Michael A. Berardi
Director
Service Engineering Operations
Ford Customer Service Division

SUBJECT: NEW VEHICLE DEMONSTRATION / DELIVERY HOLD - Safety Recall 17S33
Certain 2015-2017 Model Year F-150 and 2017 Model Year F-Super Duty Vehicles
Doors Will Not Close or Open While Driving

REF: Safety Recall 17S33 – Advance Notice
Dated: October 17, 2017

FIGURE 6

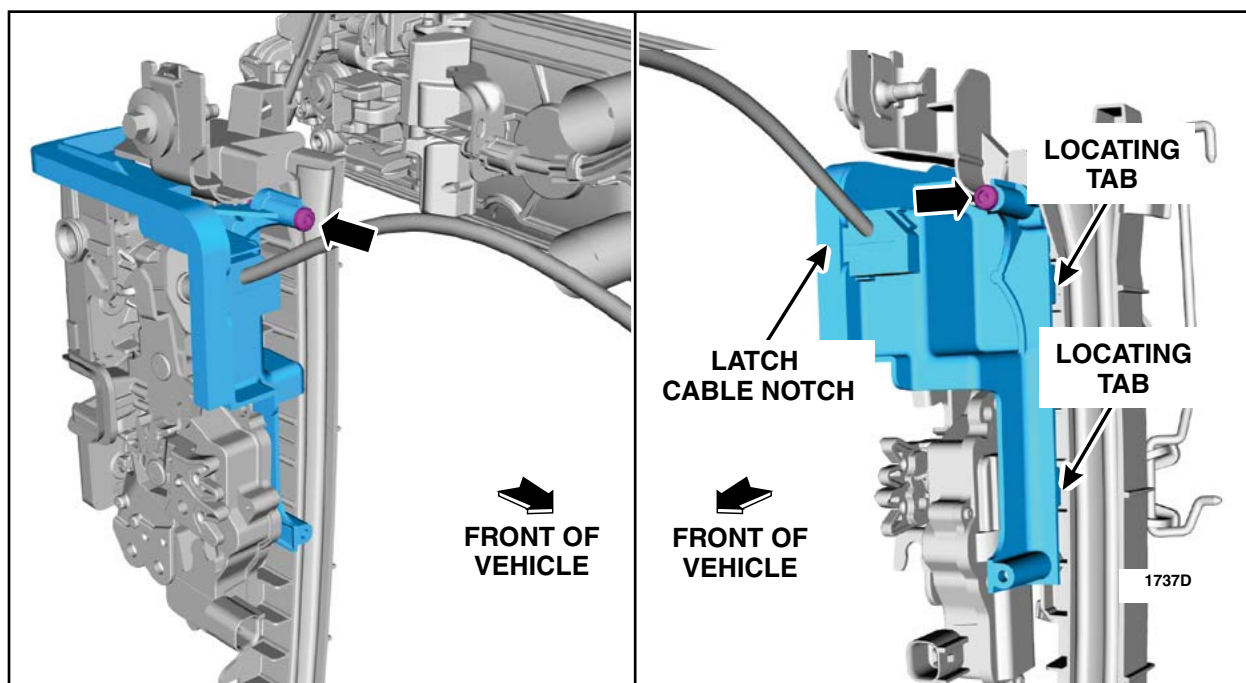
10. With the latch and door glass run assembly loose inside the door panel, install the door latch water shield into position. See Figure 6.

NOTE: The water shield is properly installed when the locating tabs align with the window run, the latch cable is fitted in the notch of the water shield, and the fastener holes align.

11. Install the *new* screw into the top hole of the shield. See Figure 6.

NOTE: The lower fastener hole of the shield is not used on the front water shields.

FIGURE 7

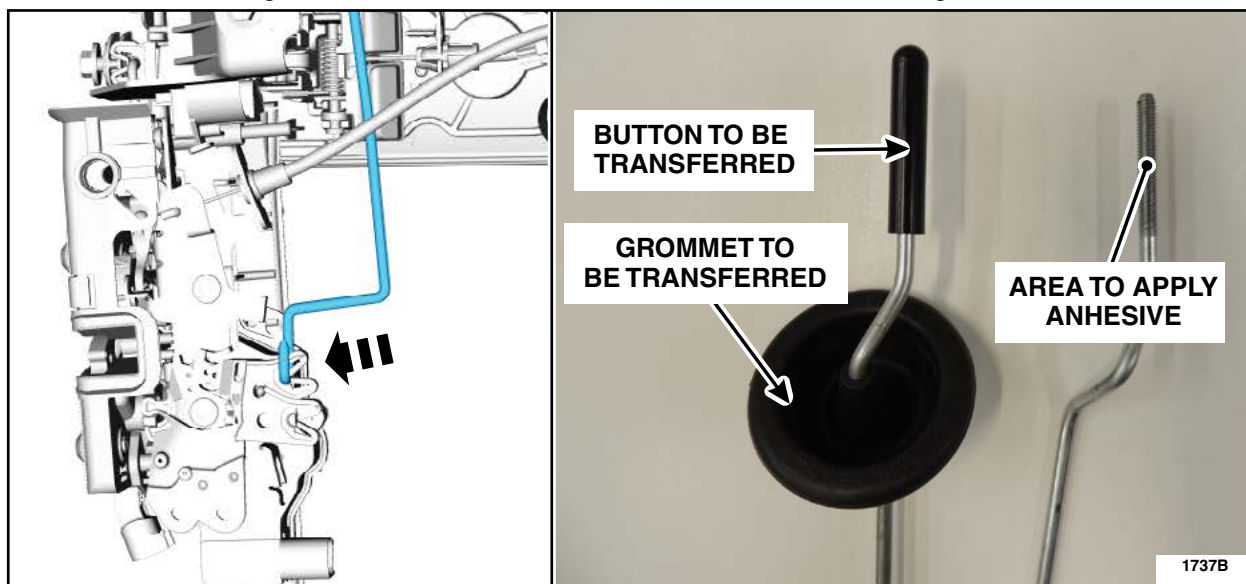
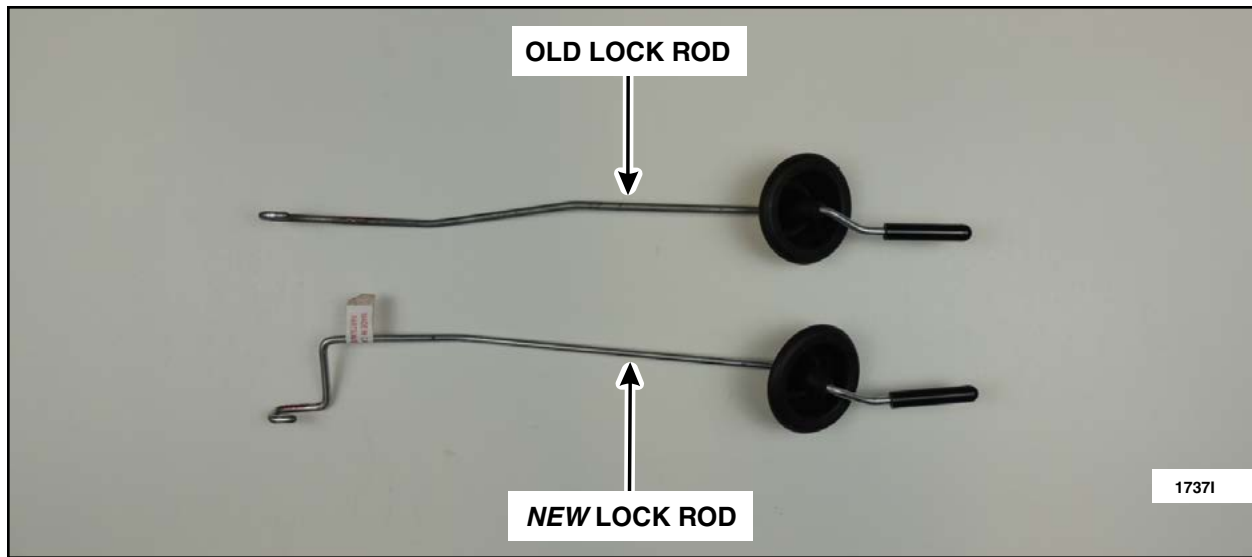
14. Was the vehicle built on or before June 1, 2016?

Yes - Install a new lock rod to accommodate the new water shield. See Figure 7 and 8.

No - Verify the vehicle has the updated lock rod shown in Figure 8 and proceed to step 15.

NOTE: If the vehicle does not already have the updated lock rod, proceed with the lock rod replacement procedure.

- Transfer the grommet and button from the original lock rod to the *new* lock rod.
- Apply a bead of Motorcraft® instant gel adhesive (or equivalent) to the lock rod prior to threading the button into place.
- When threading the button onto the *new* lock rod, stop threading when some resistance is met.
- Ensure the right-hand and left-hand buttons are installed at similar heights.

FIGURE 11

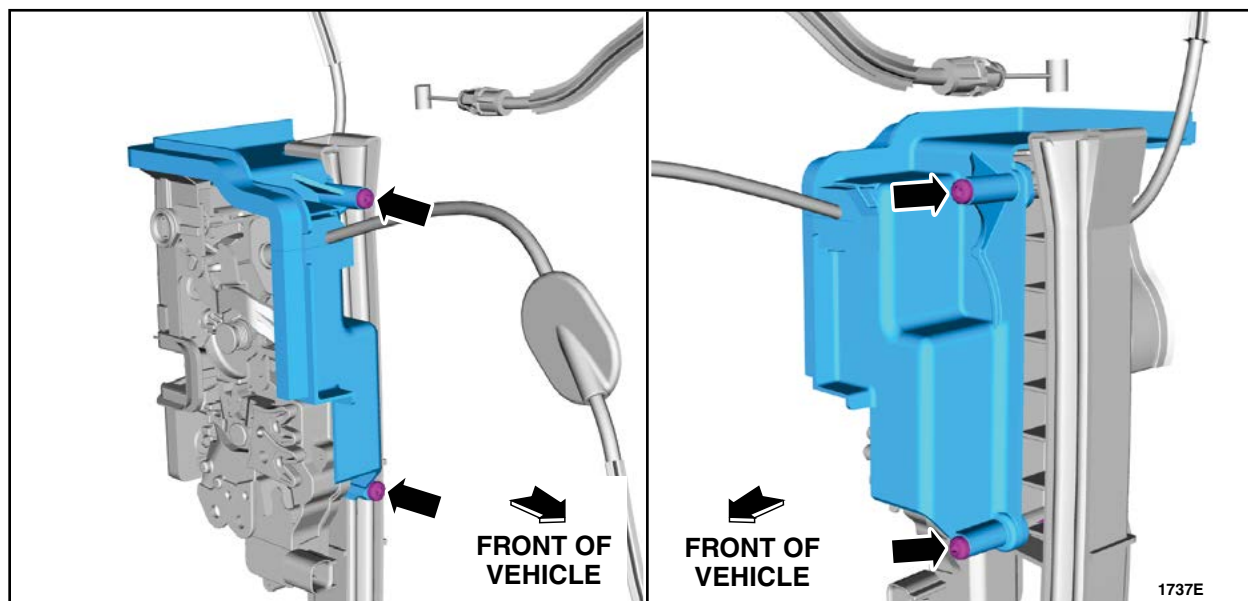
7. Install the door latch water shield into position. See Figure 11.

NOTE: The water shield is properly installed when the latch cable is fitted in the notch of the water shield and the fastener holes align.

8. Install the *new* screws into the top and bottom holes of the shield. See Figure 11.

FIGURE 12

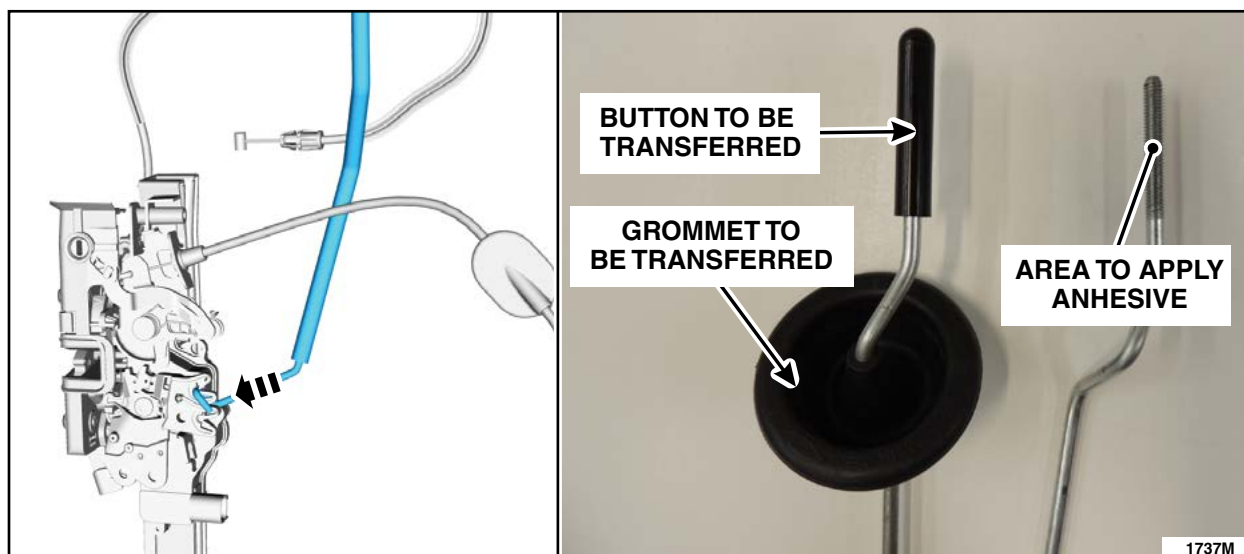
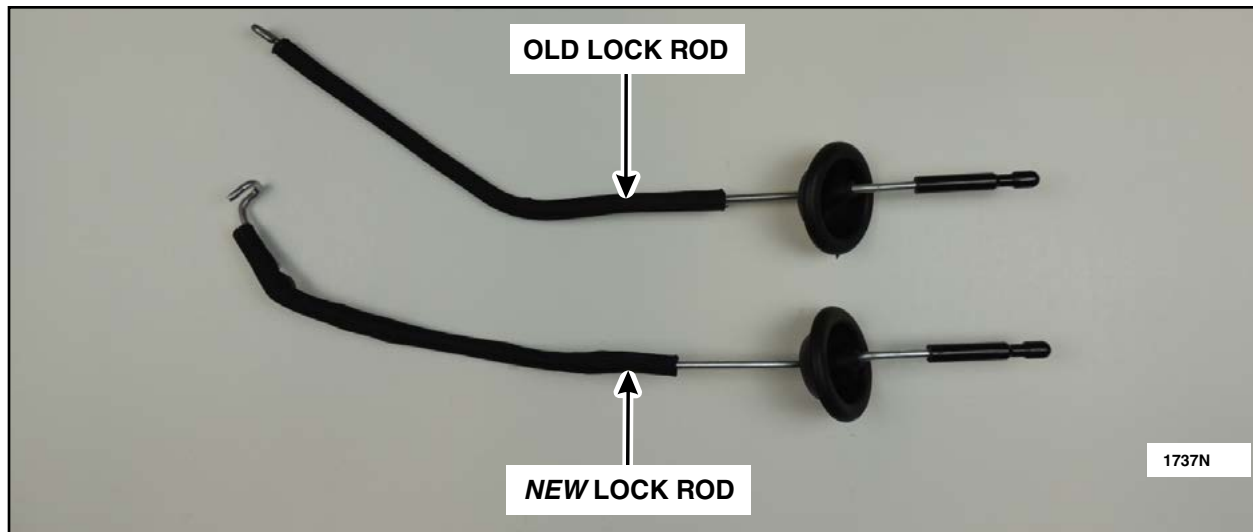
9. Was the vehicle built on or before June 1, 2016?

Yes - Install a new lock rod to accommodate the new water shield. See Figure 12 and 13.

No - Verify the vehicle has the updated lock rod shown in Figure 13 and proceed to step 10.

- For replacement lock rods only. Transfer the grommet , sleeve and button from the original lock rod to the *new*.
- Apply a bead of Motorcraft® instant gel adhesive (or equivalent) to the lock rod prior to threading the button into place.
- When threading the button onto the *new* lock rod, stop threading when some resistance is met.
- Ensure the right-hand and left-hand buttons are installed at similar heights.

FIGURE 16

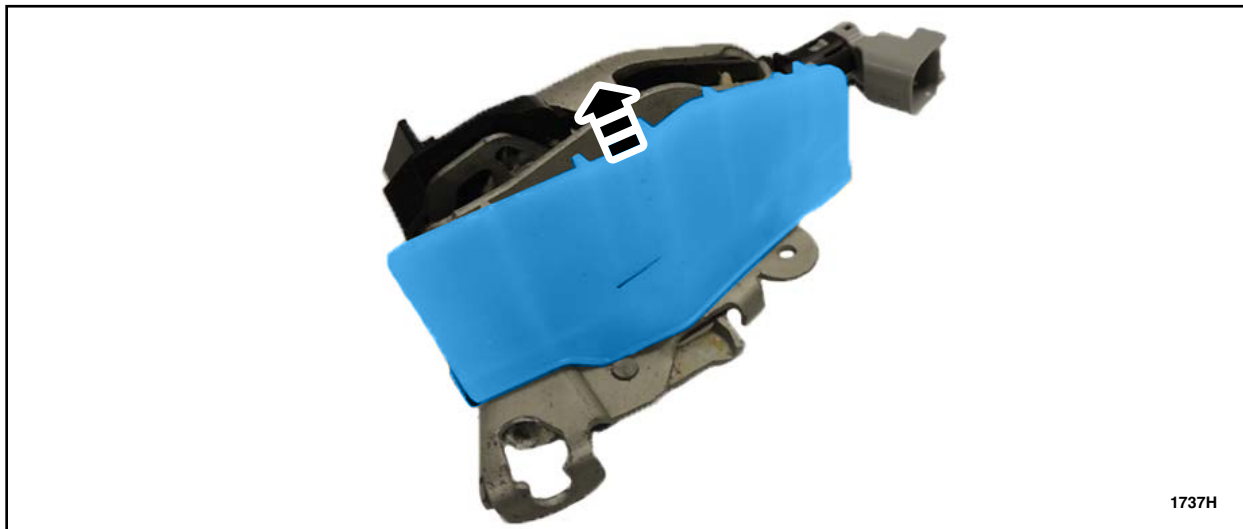
NOTE: Some F-150 SuperCab vehicles may be equipped with a smaller water shield than what is being installed in this safety recall. The smaller shields must be removed and replaced. See Figure 16.

6. If equipped, remove and discard the existing lower door latch water shields. See Figure 16.

FIGURE 17

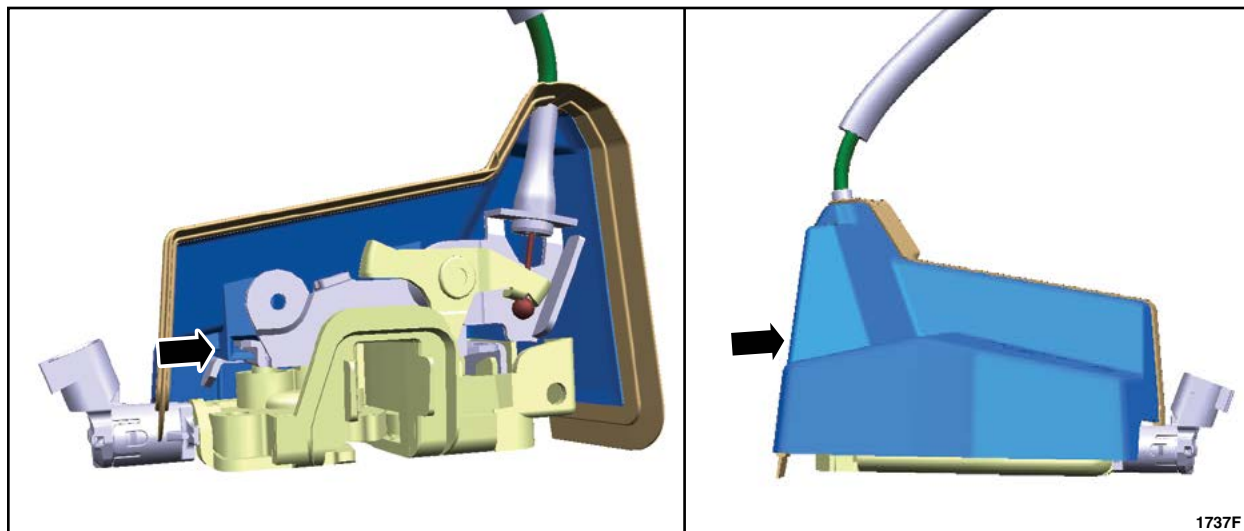
Note: If the vehicle has previously had a rear lower door latch replaced, it may already have the latest level latch water shield installed. If the Super Cab rear lower door latch has a water shield installed as shown in Figure 17, then installation of a *new* water shield is not required.

7. Using compressed air, blow out any debris or residual water from the latch assembly area.
8. Lubricate the door latch with Motorcraft® Multi-Purpose Grease or a quality equivalent white lithium grease spray.
 - Do not use penetrating oils on the latches.
9. Install a *new* door latch water shield onto the lower rear door latch. See Figure 17.
